Re: Peer Review of Notice of Intent – 135, 139, 149R Howard Street, Reading, MA
MassDEP File No. 270-0714

The Horsley Witten Group, Inc. (HW) is pleased to provide the Town of Reading Conservation Commission with this letter report summarizing our initial review of the Notice of Intent, Drainage Report, and plans for developing the site at 135, 139 & 149R Howard Street, Reading, Massachusetts. The plans were prepared for Infrastructure Holdings LLC (Applicant) by Civil Design Consultants, Inc. The project consists of the demolition of two single family residential houses and the construction of a six-lot residential subdivision with a 346-foot roadway, including landscaping, utility installation, and stormwater management. The 4.1-acre project site includes 0.53 acres of bordering vegetated wetlands (BVW) on the northern end of the site. The proposed work is within the 100-foot buffer zone of the BVW. The proposed new development includes a 25-foot zone of natural vegetation from the BVW.

Figure 1. 1944 USGS Topographic Map Reading Quadrangle (southwest quadrant) (left image) and Figure 2. 1951 USGS Topographic Map Reading Quadrangle (southwest quadrant) (right image). The approximate location of the site is circled in blue.

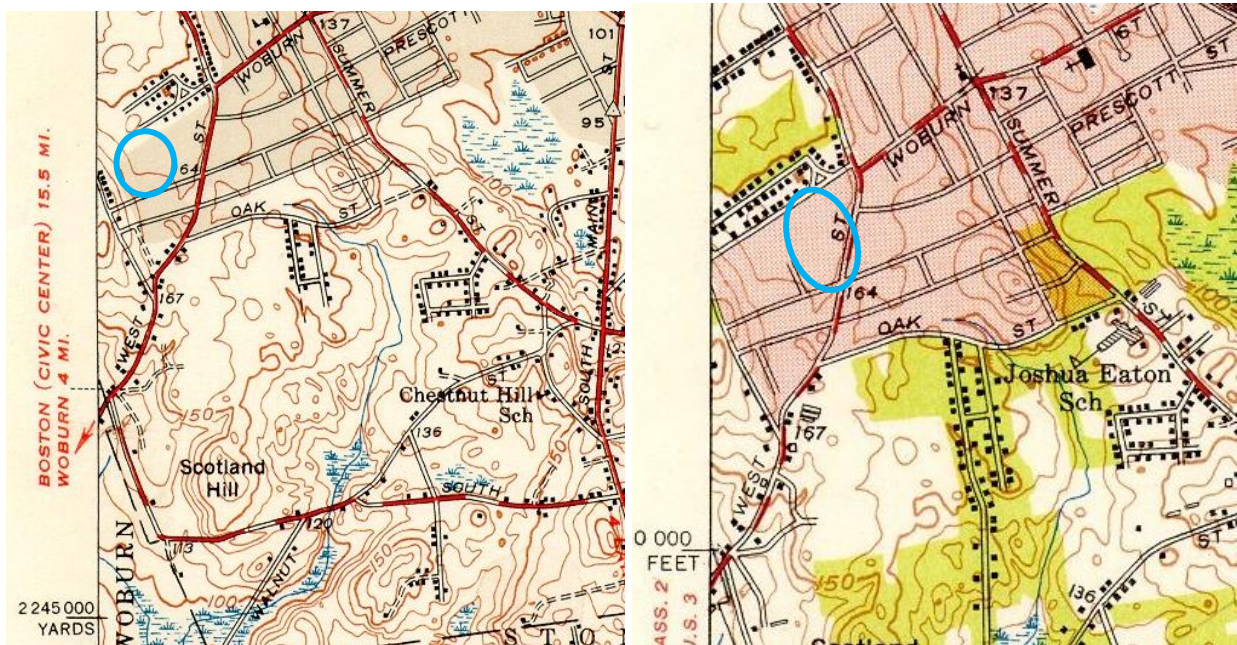
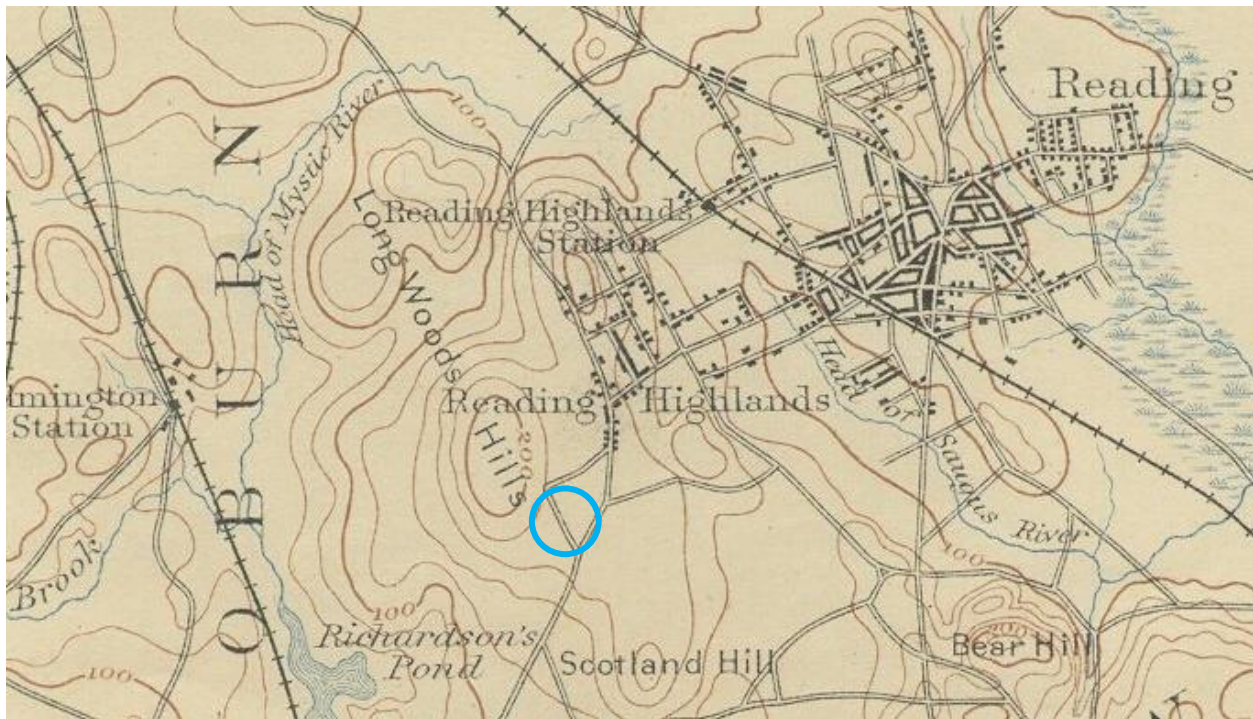
- d. HW also conducted a brief review of available historic USGS maps to see if this provided any insight regarding the site hydrology as suggested in the letter by one of the abutters (letter by Charles Castelluccio dated February 26, 2019). Unfortunately, these maps (Historic USGS Maps of New England & NY available from the University of New Hampshire Library, Government Information Unit; <http://docs.unh.edu/towns/MassachusettsTownList.htm>) do not provide definitive evidence of a wetland or stream channel in this general area (see Figures 1 through 3).
